**From:** Ric Blenkharn  
**Sent:** 29 April 2020 16:44  
**To:** Jill Bastow  
**Cc:** 'Neil Ramsey'; 'Tris Terry'  
**Subject:** RE: Re: Newgate Hackness

**From:** Ric Blenkarn  
**Sent:** 30 April 2020 11:06  
**To:** Jill Bastow  
**Cc:** Tris Terry; Ric Blenkarn; Neil Ramsey  
**Subject:** Newgate Hackness  
**Attachments:** 1346\_AR10\_02\_E Context.pdf; 1346\_AR10\_01\_E Site.pdf

Project  
**The Newgate Estate**  
Address  
Highdale, Hackness, Scarborough, YO13 0JU  
Client  
**The Ramsey Family**

Drawing  
**SITE PLAN AS PROPOSED**

Sheet Size	Drawn	First Issue Date	DMYY
A1	TJT	14/06/2019	
Scale	Checked	Drawing No.	Rev.
1:200	RAB	1346_AR10_01_E

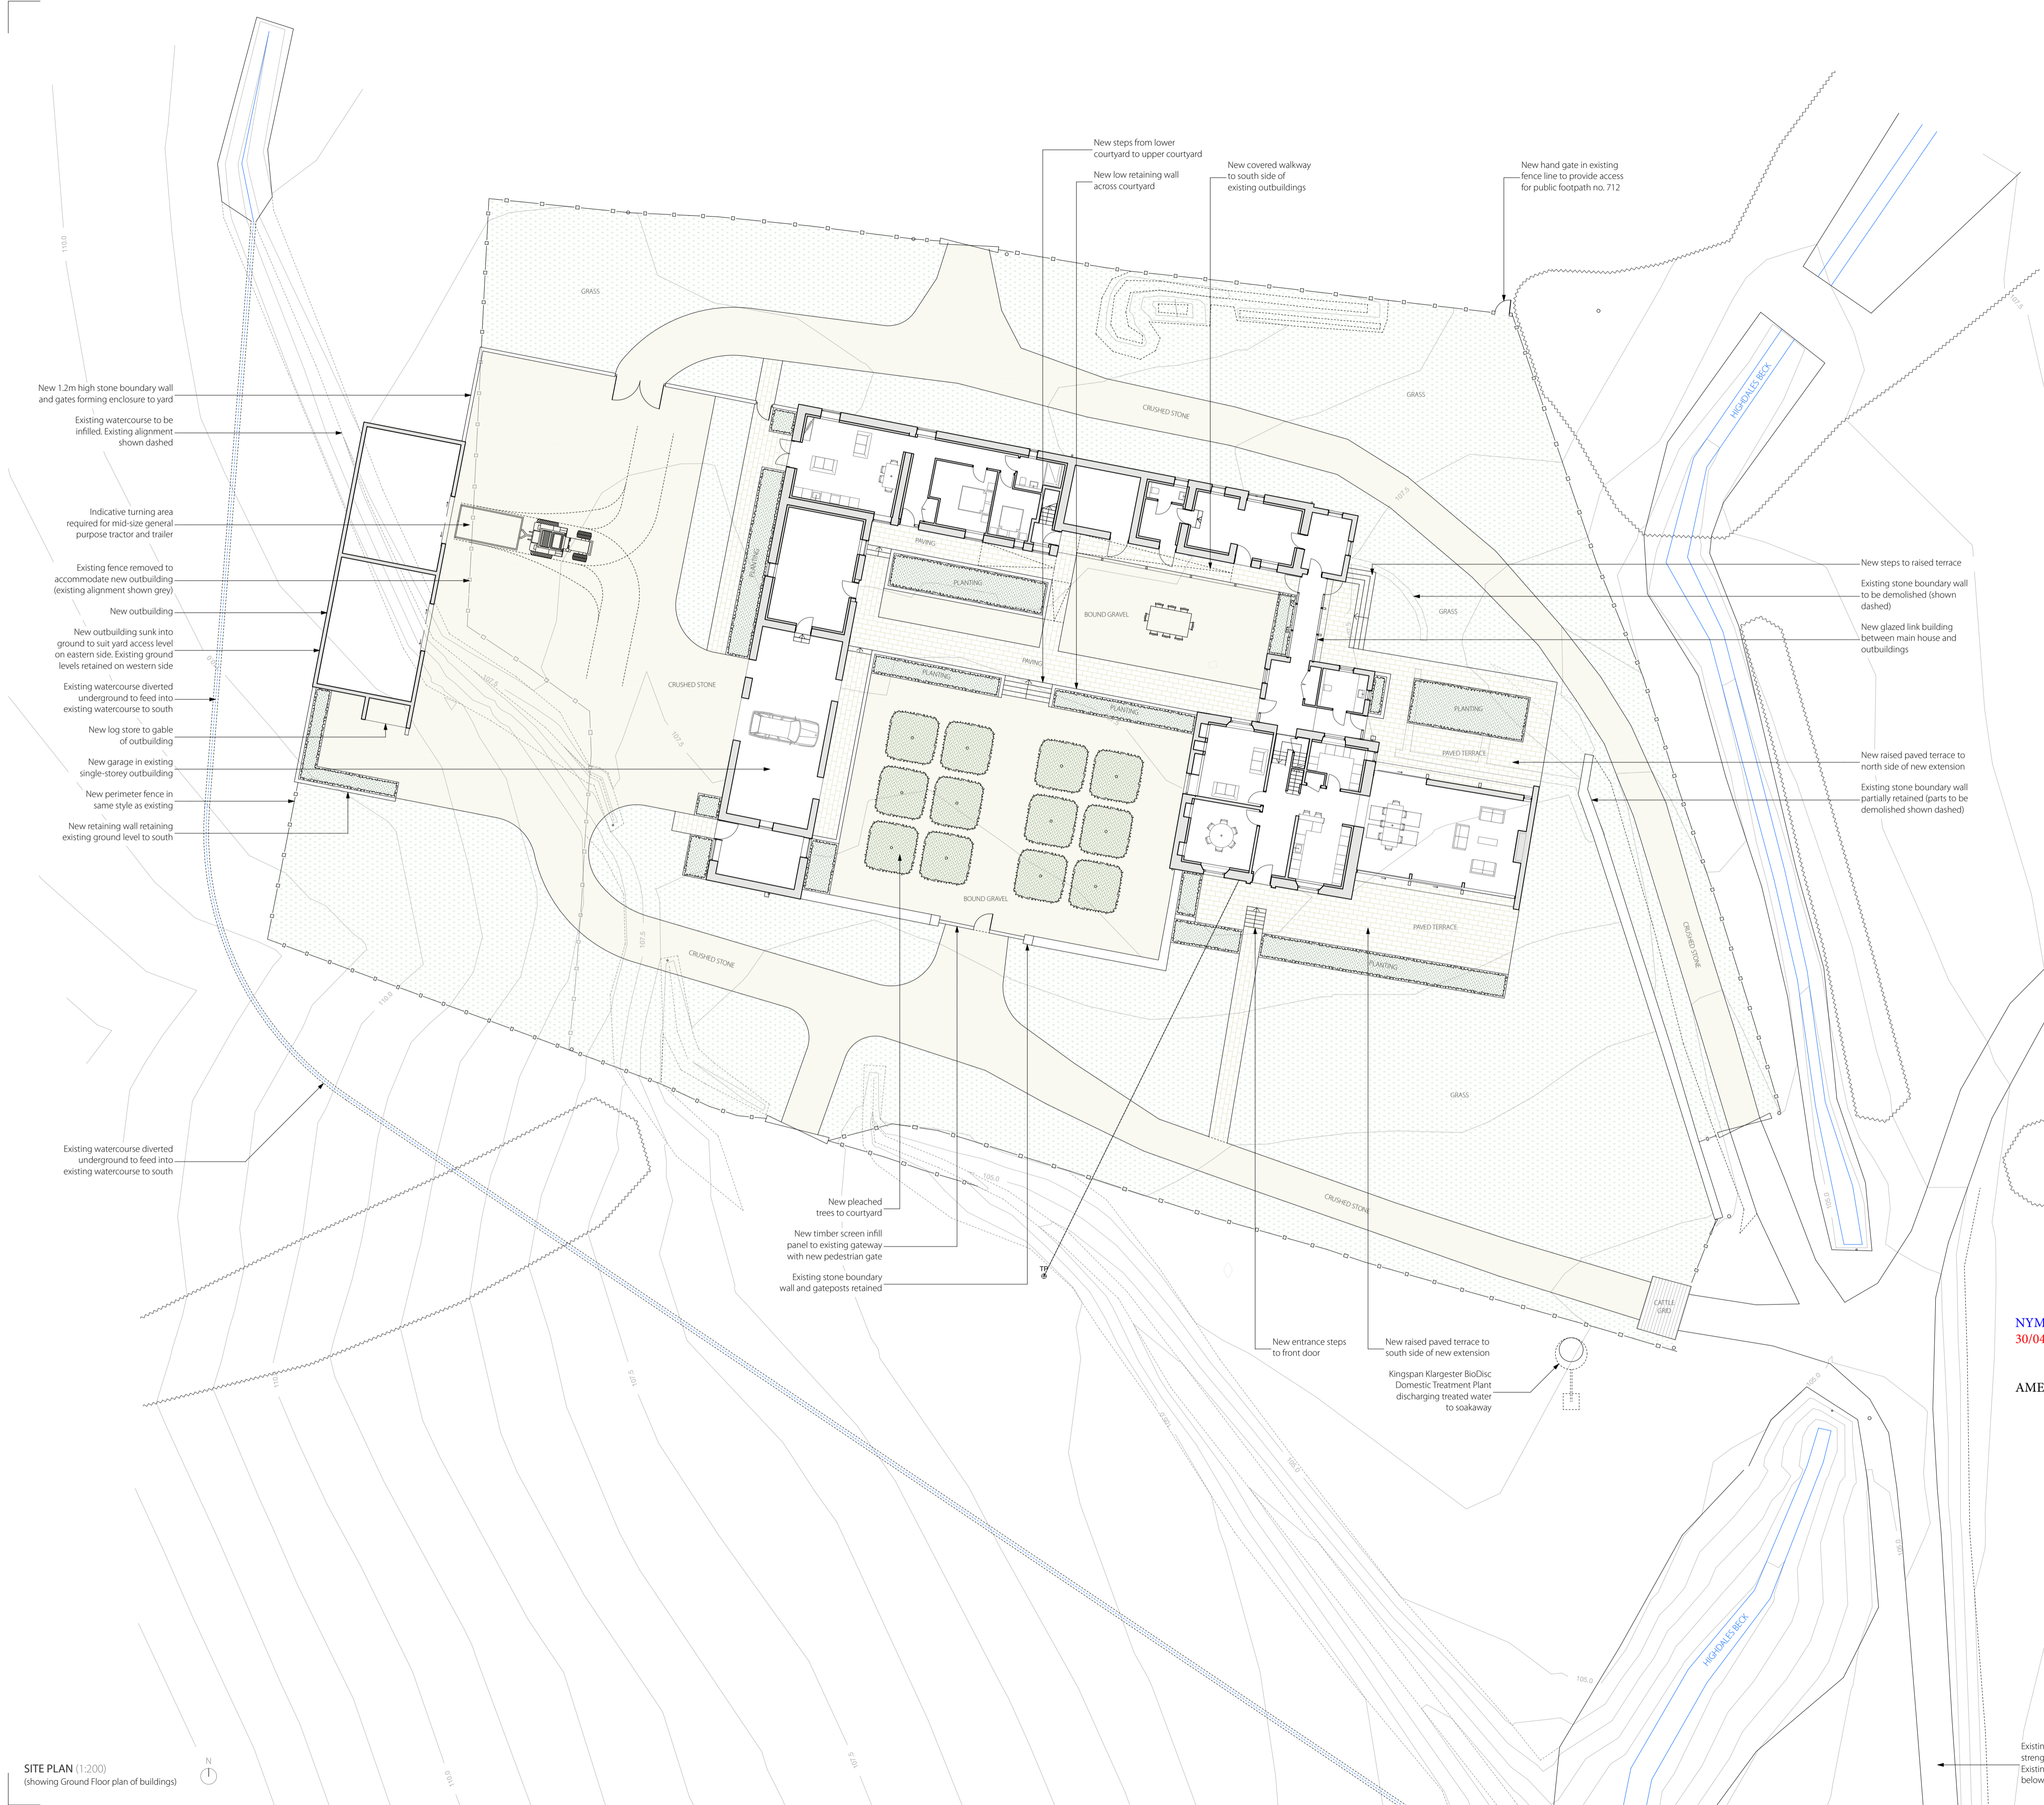
I am enclosing updated drawings 1346 AR 10 02 E and 1346 AR10 01 E noting the proposed reinstated gate in the northern boundary for footpath 712. Please do let me know if you require anything further. I should have the updated Ecology report shortly, once the sampling tests are back and then Wolds Ecology will forward the report.

Rev	Date	Drawn	CHK'D	Description
E	30/04/20	TJT	RAB	Hand gate added to public footpath in NE boundary fence
D	09/04/20	TJT	RAB	Revised following LPA comments
C	24/10/19	TJT	RAB	Key plan updated
B	11/09/19	TJT	RAB	Treatment plant position added
A	30/08/19	TJT	RAB	Changed to "Planning Issue"
P2	15/07/19	TJT	RAB	Revised following client comments
